Response to Comments

## **Chapter 2. Federal Agencies Comment Letters**

RE: DRAFT PROGRAM ENVIRONMENTAL IMPACT REPORT/ENVIRONMENTAL
IMPACT STATEMENT (EIR/EIS) FOR THE PROPOSED CALIFORNIA HIGH
SPEED TRAIN SYSTEM

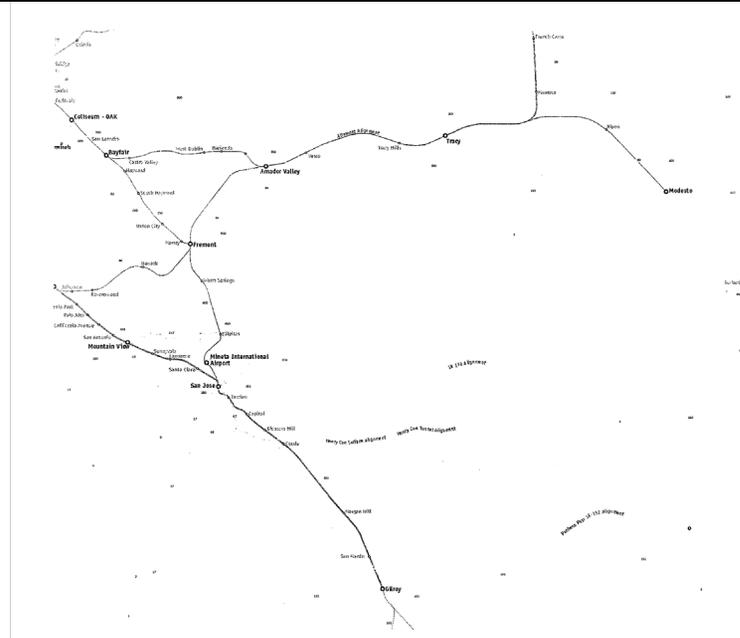
- Please study the enclosed map.
- Altamont has the shortest overall route miles for the complete system including Sacramento — meaning it would save billions.
- PCL, Sierra Club, other environmental groups support Altamont and oppose the Diablo (east of San Jose) routing through the largest remote wilderness area in the region.
- <http://www.arch21.org/CaHighSpeed.dir/hsrindex.html> explains these issues and more — an excellent and well researched report on the web.

Please see standard response 2.18.1.
